# 2ND & BELL

SDCI Project #3020027-LU

Recommendation Packet | REC

Meeting Date : MAY 24TH, 2022

SCHEME 2 FROM ARC MEETING #4

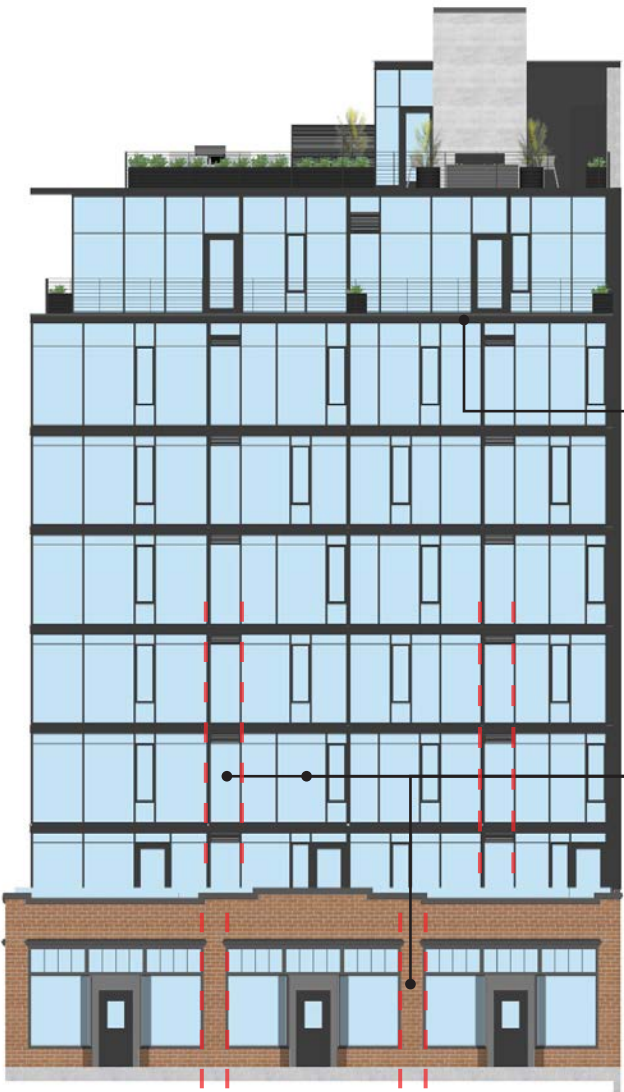
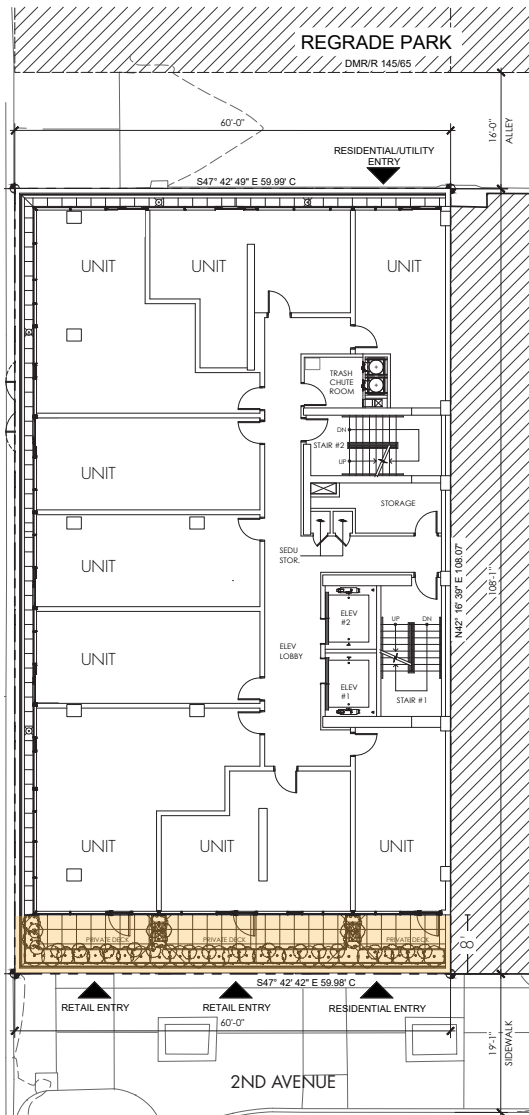
**Meeting #2 Board Key Comments:**  
1. Glass tower is supported but to be differentiated from the historic structure and less dominant  
2. Preserve historic building as much as possible

**Meeting #3 Board Key Comments:**  
1. Respond to historic building's roofline  
2. Study the tower roof and window walls  
3. Explore recess (modulation) opportunities at the upper massing  
4. Bring back the gasket if possible

**Meeting #4 Board Key Comments:**  
1. Window patterns to respond to the landmark building below  
2. Further setback on 2nd Ave Encouraged

- 1. Preserve and restore the existing building facade to the original state, and separate the old and the new volumes.
- 2. Use of simple form and glass were supported by the board, as it allows the landmark structure to remain distinctive while the addition appearing to be light.
- 3. Proposed project is further developed based on Scheme 2 which was supported by the board from ARC meeting #4.
- 4. The glass facade design respond to the landmark building below through adopting an alternating rhythm that simulates the layout of landmark building storefronts. The window frame color also matches the trims on the landmark building.

SITE PLAN

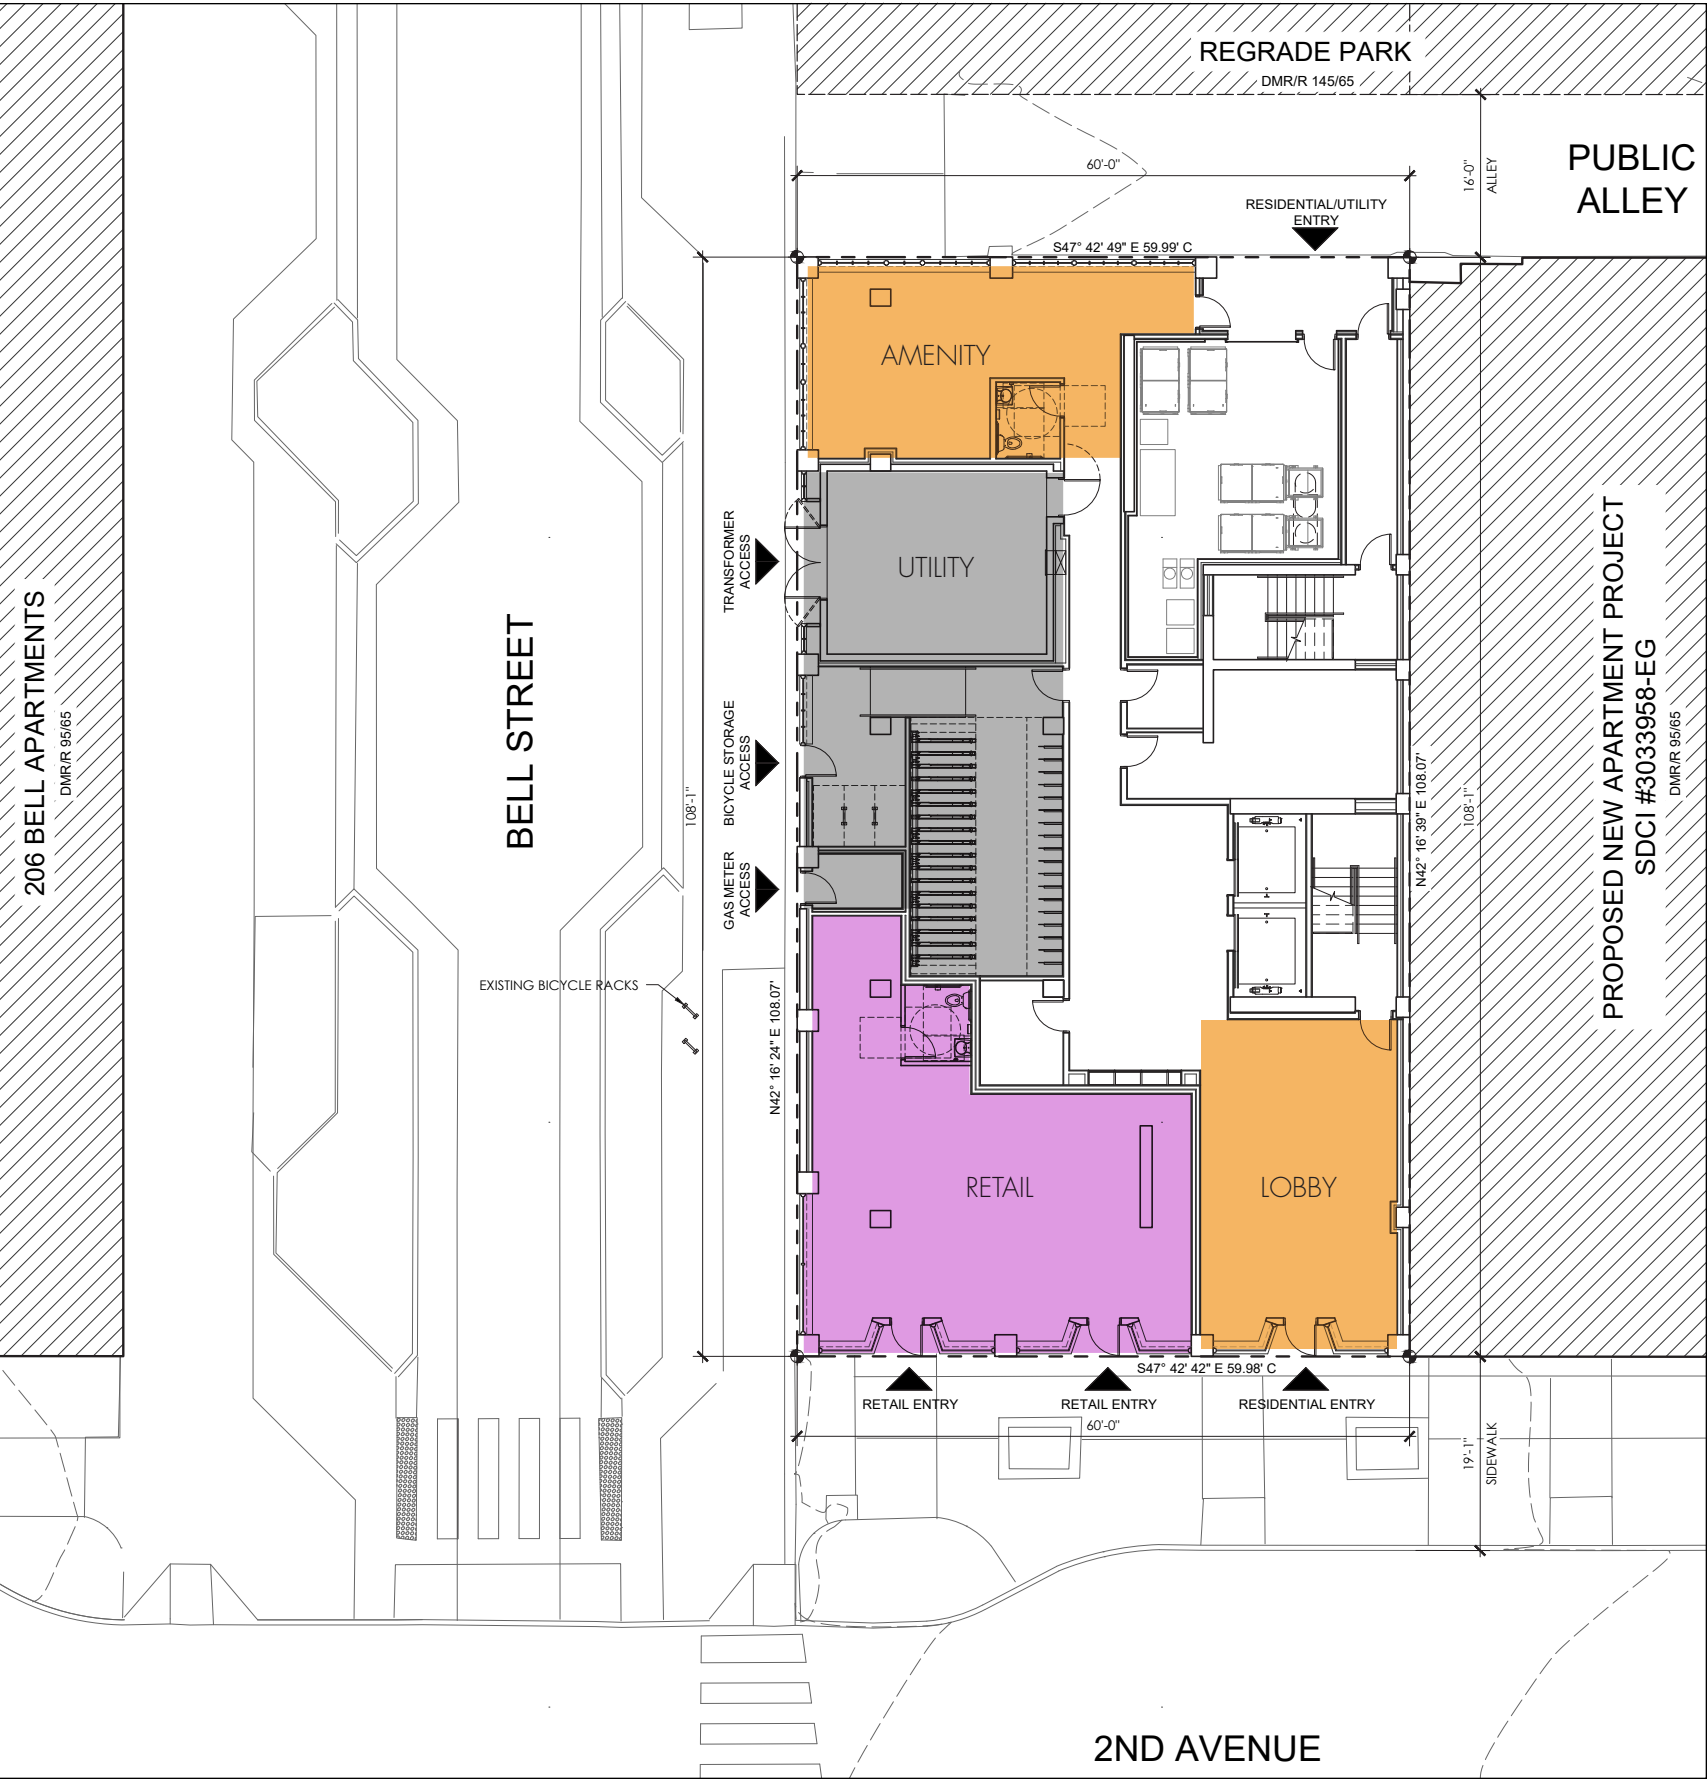
b. While the ground floor of each concept was supported, the Board agreed the lobby should be on 2nd Ave or Bell St and not the alley (A1-1, C4-2)

b: We agree with the Board and have designed the Lobby to be located along 2nd Ave.

SOUTHWEST ELEVATION

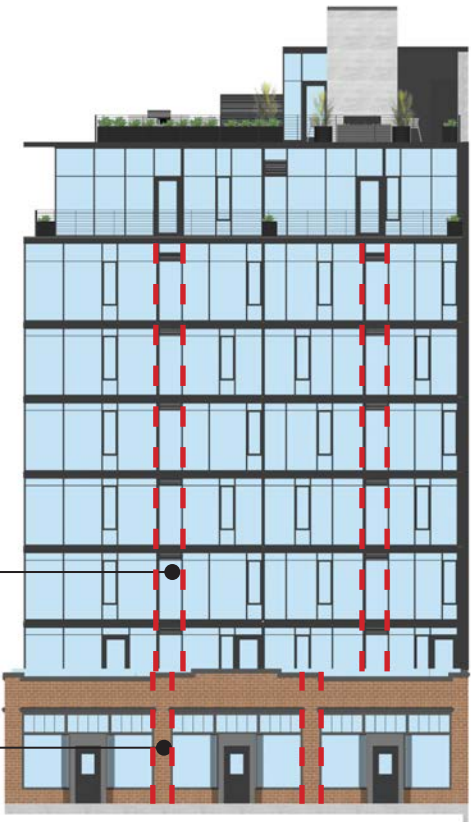
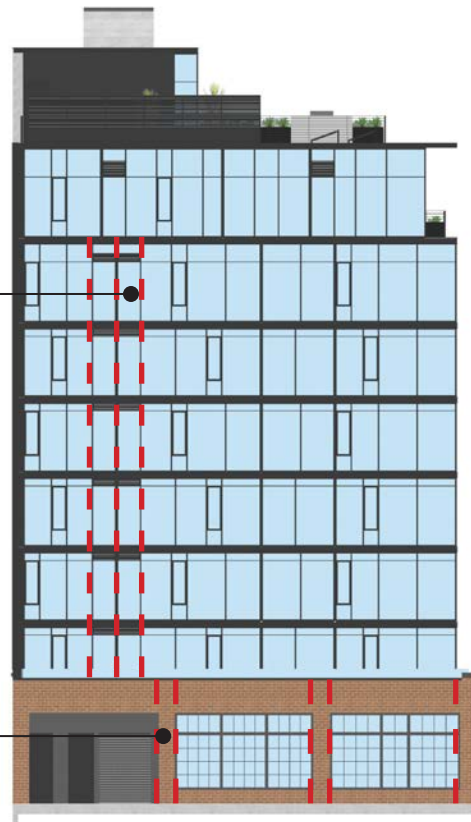
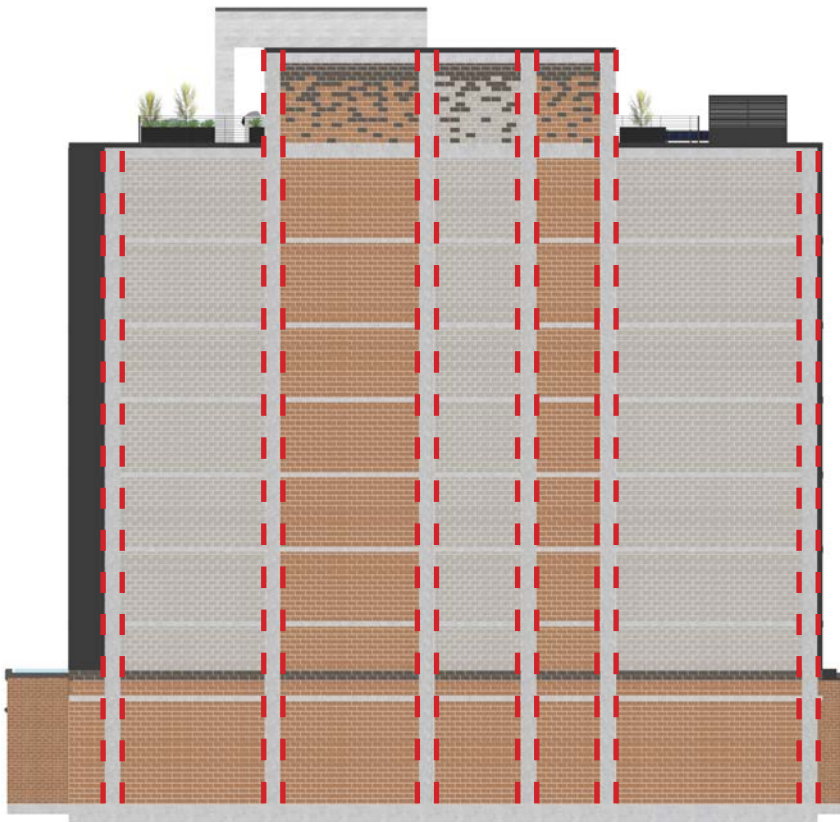
b. Speaking to the immediate context, the Board noted buildings that express an articulation of parts, while others a continuous skin with punched windows. The Board agreed the project should respond to the neighborhood context, and recommended exploration of continuing the storefront language of 2nd Avenue with a contemporary tower above. Use of glass was supported. Scale, mass, texture, and materials will be important elements of expressing the architectural concept. Include these details in the Recommendation packet. (A1-1, B1-I, B1-II, B1-III, B1-IV, B2-1, B2-2, B3-1)

c. Portions of the building will be visible from all sides. For this reason, the Board recommended all facades be carefully detailed to clearly express the architectural concept. The concept should be the applicant's interpretation of the Belltown character. (A1-1, B1-I, B1-II, B1-III, B1-IV, B2-1, B2-2, B3-1)

b: Since the EDG meeting the building has been designated as a Landmark. The first level of the building will remain the Landmark structure, while the upper levels will be new construction and create a contemporary glass tower per the Board's recommendation. The main mass is simple and responds to the storefront windows of the Landmark building in terms of scale and location. Scale, mass, texture and materials were all taken into account when designing the upper levels. The upper level is set back to provide a terminus for the building as well as outdoor space for the units. The materials are simple with glass and steel so that they will not detract from the Landmark structure at the ground level. The expressed thicker mullions at the operable windows add residential scale and feel to the upper level mass, and provide articulations to the building facade and served as facade modulation.

c: Since the EDG meeting the building has been designated as a Landmark. All sides of the building have been designed equally and the design concept has been consistent on all sides and feel to the upper level mass, and provide articulations to the building facade and served as facade modulation. Also, the top portion of southeast wall which is adjacent to the property will be visible, so the design was focused on upper level of the southeast wall.
